# Access Compliance Report

## Public Rights-of-Way

### (Curb Ramps)

Intersection ID: 30548	Main Street: SOUTH_BV	Cross Street: CAROLINA_PAVILIION_DR_S	Location: NE
ADA ID: DE9F464DE9D0	Ramp Type: BlendTrans2	Initial Pass/Fail: Fail	Overall Compliance: No
Severity Score: 21.25			
Codes/Mitigation Info/Possible Solution		Field Measurements/Component Compliance

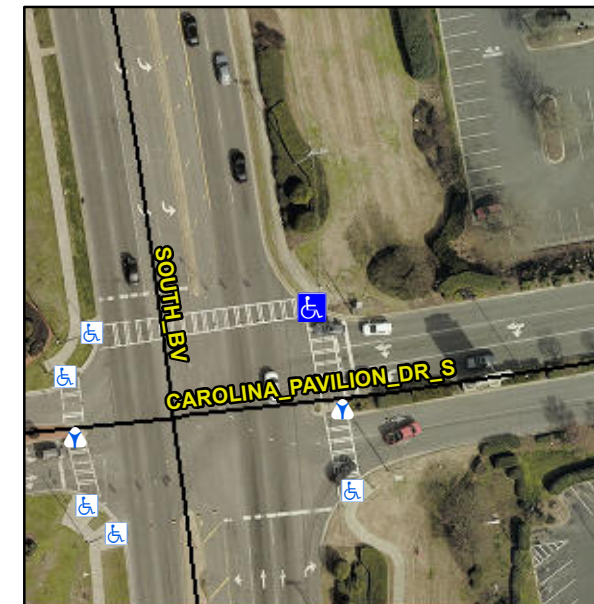
**Not Found, R304.5.1, R304.5.3**

Compliance	Description	Data	Compliance	Description	Data
N/A	Ramp Length (in)	109.0	Yes	BlendTrans Slope (%)	4.1
No	Ramp Width (in)	47.0	No	BlendTrans XSlope (%)	5.3
N/A	Flare Type LT	N/A	N/A	Flare Type RT	N/A
N/A	Flare Slope LT (%)	N/A	N/A	Flare Slope RT (%)	N/A
N/A	Flare Traversable LT?	N/A	N/A	Flare Traversable RT?	N/A
N/A	Landing Length (in)	N/A	N/A	DWS Provided?	N/A
N/A	Landing Width (in)	N/A	N/A	DWS Contrast?	N/A
N/A	Landing Slope (%)	N/A	N/A	DWS Length (in)	N/A
N/A	Landing X Slope (%)	N/A	N/A	DWS Full Width?	N/A
N/A	Landing Curb? (Y/N)	N/A	N/A	DWS Offset (in)	N/A
N/A	Shared Landing?	N/A			
N/A	Gutter Ponding?	N/A	N/A	Gutter Slope (%)	N/A
N/A	Gutter Lip Ht (in)	N/A	N/A	Gutter X Slope (%)	N/A
N/A	Painted X Walk1?	Yes	N/A	Painted X Walk2?	Yes
	X Walk 1 Direction	To W		X Walk 2 Direction	To S
	X Walk 1 Width (in)	106.0		X Walk 2 Width (in)	134.0
	X Walk 1 Slope (%)	4.9		X Walk 2 Slope (%)	2.8
	X Walk 1 X Slope (%)	0.9		X Walk 2 X Slope (%)	1.0

N/A	Ramp inside XWalk1?	Yes	N/A	Ramp inside XWalk2?	Yes
	Road Slope (%)	1.0		Clear Space?	N/A
	Road X Slope (%)	2.4	N/A	Clear Space to XWalk (in)	N/A
N/A	Any Obstructions?	N/A	N/A	Storm Grate/Utility Hazard?	N/A
	Obstruction Type			Storm Grate/Utility Type	
		N/A			N/A
		Yes		Surface Condition? (G/P)	Good
		No		Curb Slope (%)	6.7

**Remove & Replace Curb Ramp With Two New Directional Ramps or Equivalent.**
